PCN #: 2590

PCN Title: Qualification of Additional Clip Bonding, Lead Frame Structure (Matrix) and Mold Compound for Select Automotive Products

**PRODUCT CHANGE NOTICE****PCN-2590 REV1**

**Figure 1: Comparison of SMA Package Construction for SKY and SBR products**

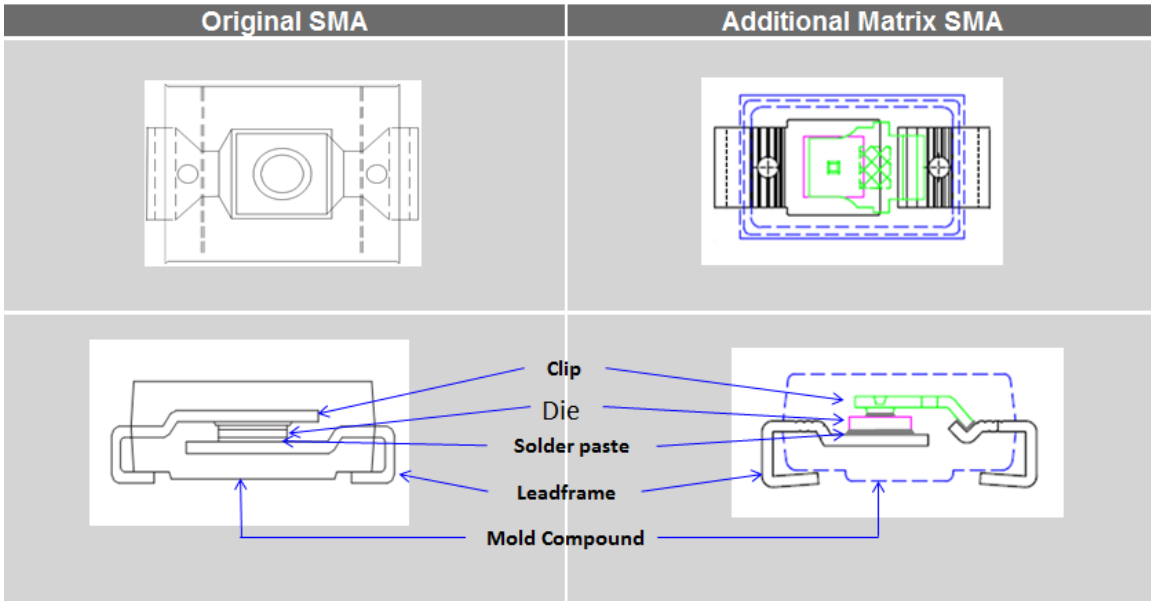
Notification Date:	Implementation Date:	Product Family:	Change Type:	PCN #:
1 June, 2022	1 September, 2022	Discrete - Automotive	Clip Bond, Lead Frame, Mold Compound	<b>2590</b>
<b>TITLE</b>				
Qualification of Additional Clip Bonding, Lead Frame Structure (Matrix) and Mold Compound for Select Automotive Products				
<b>DESCRIPTION OF CHANGE</b>				
<p>This PCN is being issued to notify customers that in order to assure continuity of supply and to improve assembly manufacturability, Diodes Incorporated has qualified additional clip bonding, lead frame structure (Matrix), and mold compound at Diodes subcontractor Eris Technology Corp. (ERIS) in Taoyuan City, Taiwan for select Automotive products.</p> <p>Full electrical characterization and high reliability testing has been completed on representative part numbers to ensure no change to device functionality or electrical specifications in the datasheet. Refer to the attached qualification report embedded in this file (to view, download this PCN file then open it with a PDF viewer to see the attached qual report).</p> <p>There will be no change to the Form, Fit or Function of affected products unless specifically indicated (see figures 1 – 5).</p>
